# 101 W. ROY ST.

SDCI# 3036111-LU (3035904-EG)  
DESIGN REVIEW BOARD RECOMMENDATIONS  
TBD

# ADMINISTRATIVE EARLY DESIGN GUIDANCE - BUILDING MASSING

# BUILDING DESIGN - SUSTAINABILITY

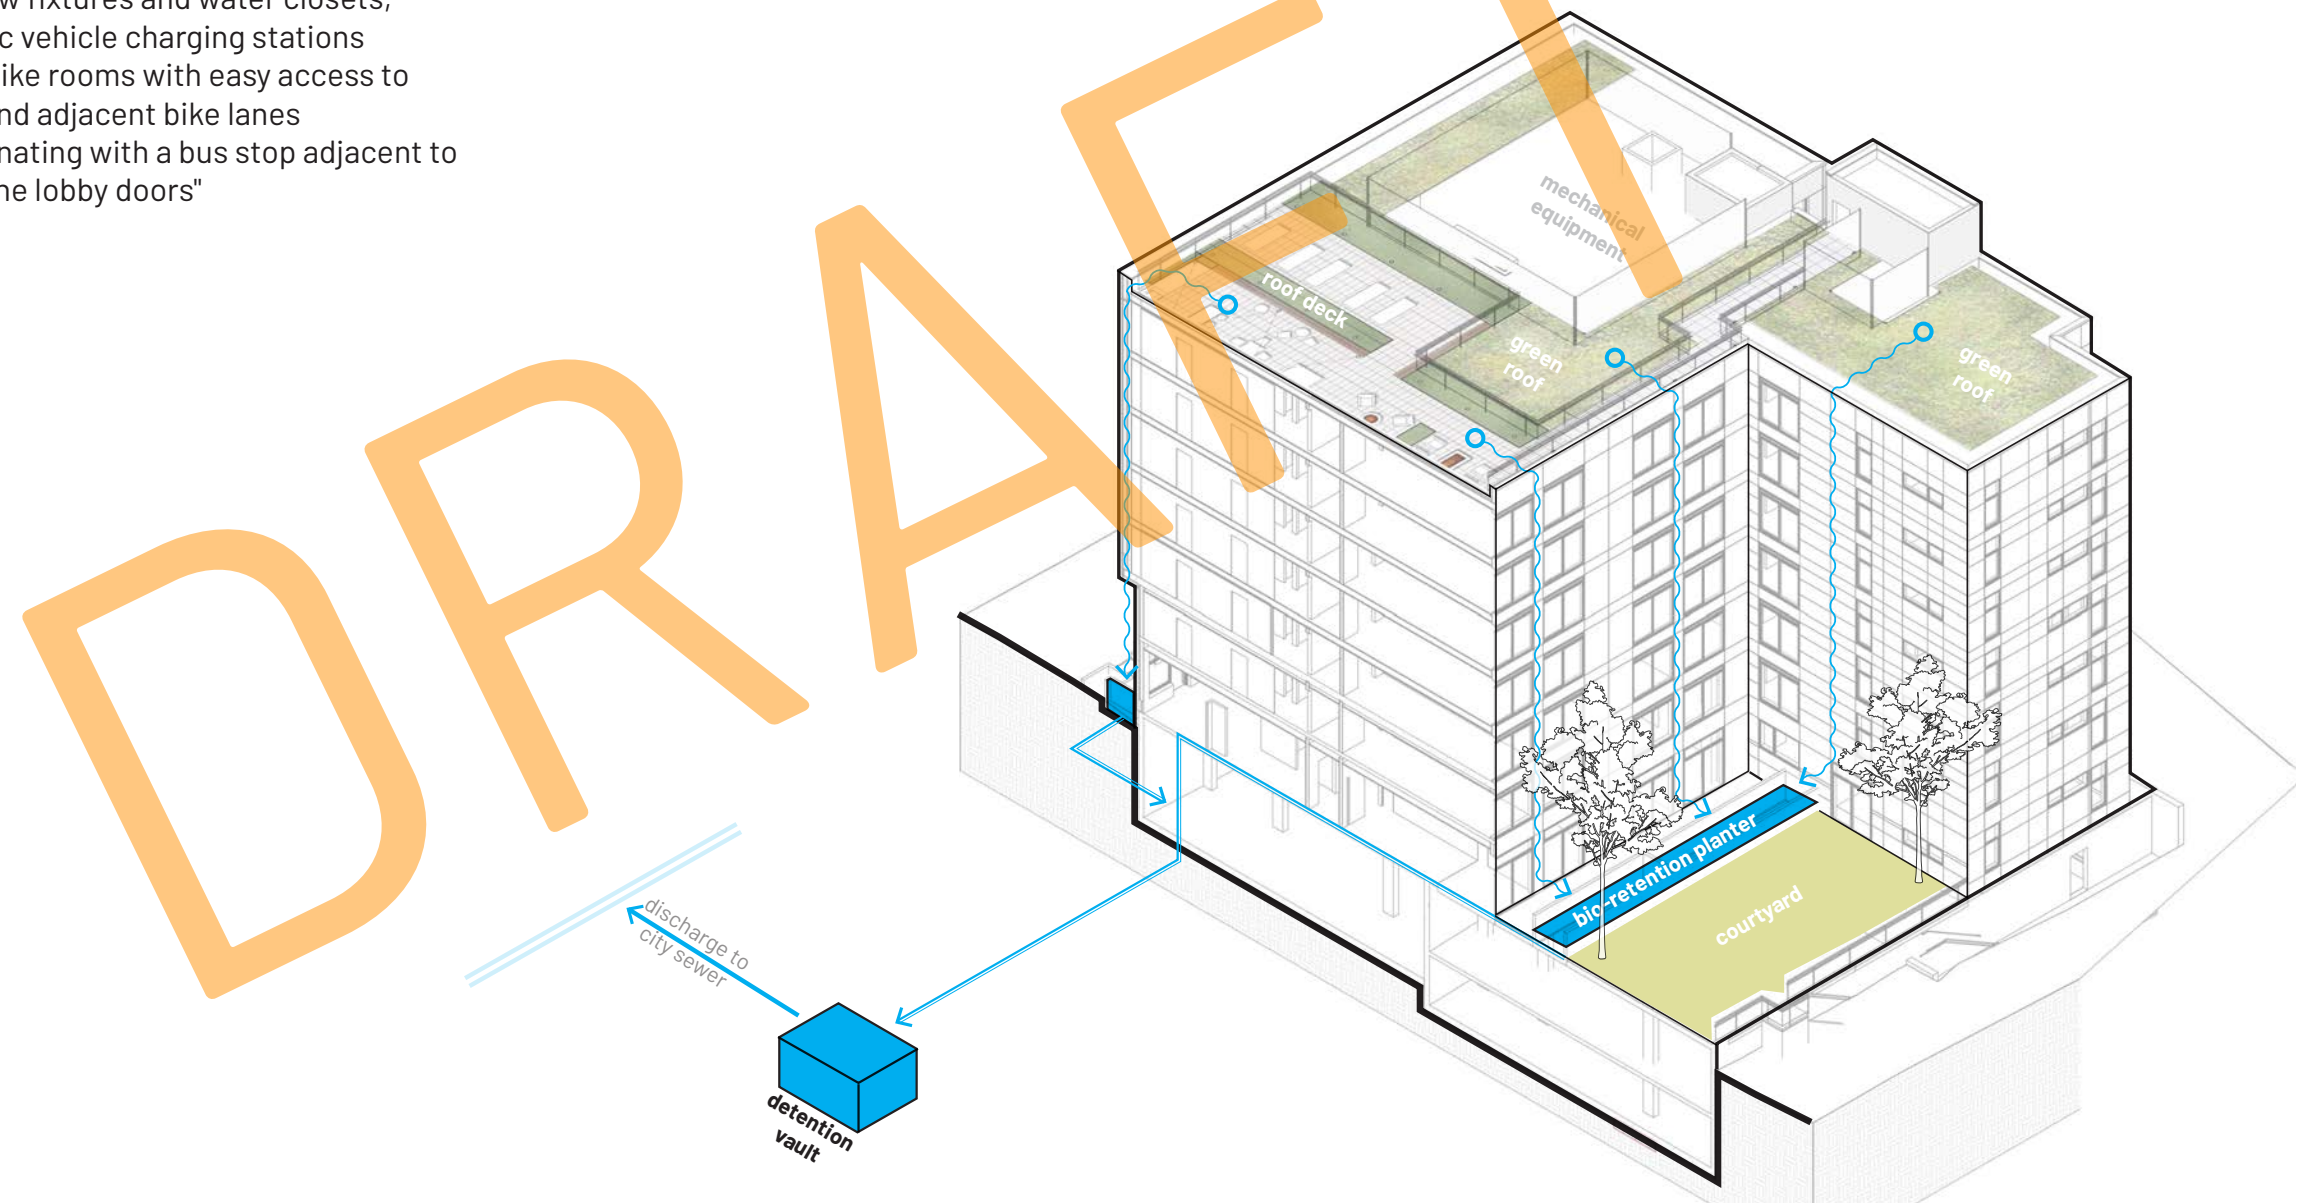
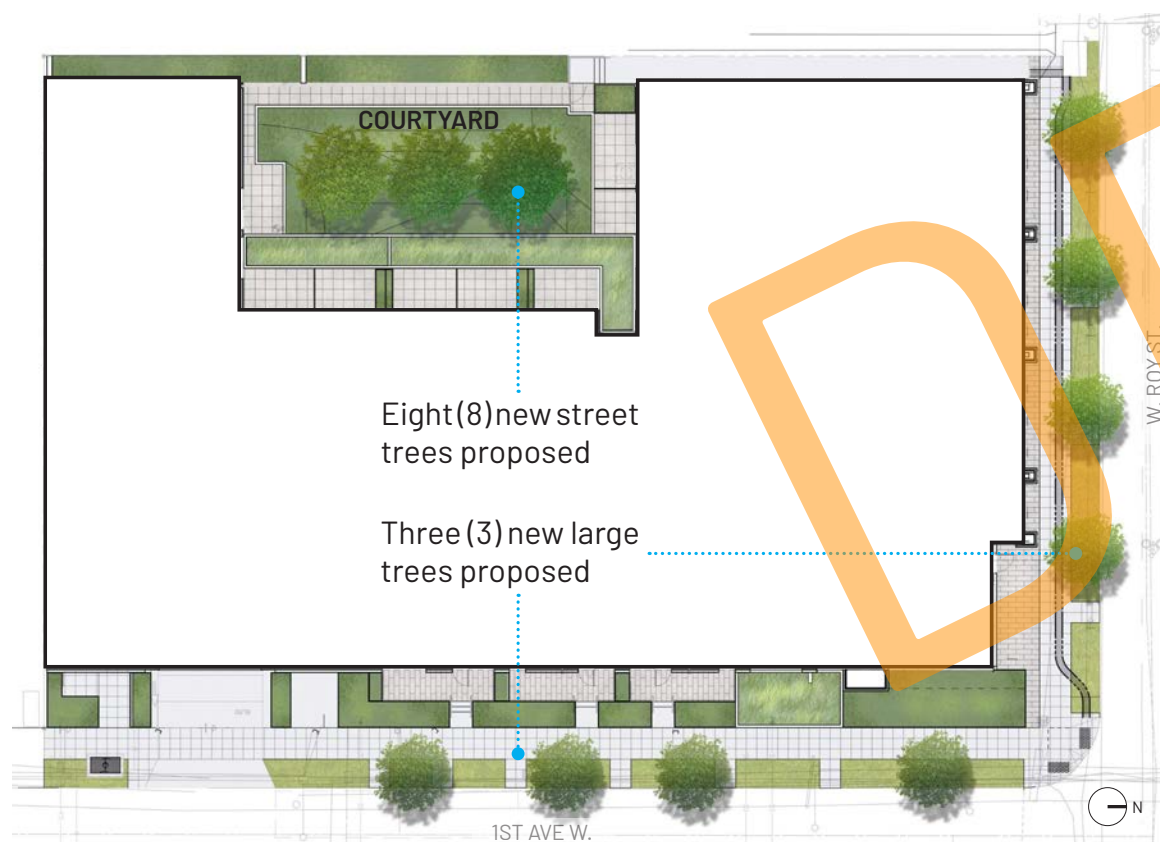
ADR guidance: prefers to see how proposed project highlights sustainability aspects related to overall form, water features, and significant tree removal. (CS1-A, CS1-B, CS1-C, CS1-D, CS1-E, CS1-2, DC4-D and DC4-E)

The form of the building is organized to provide a significant courtyard facing west bringing light and air to the most units. Large trees are planted in this courtyard to shade and assist with solar gain

The building design incorporate architectural and landscape features to highlight the natural processes of rain water collection and its movement through the site. The bio-retention planters, green roofs, and rain-gardens provide a sustainable ways of water retention, bringing the natural elements into the urban setting.

The proposed design provided 8 new trees along 1st Ave W. and W. Roy St., and 3 new large trees in the courtyard, along with significant planting and other smaller trees and shrubs mixed in. All of this mitigates the loss of two significant trees on site and three other trees considered noxious weeds by King County.
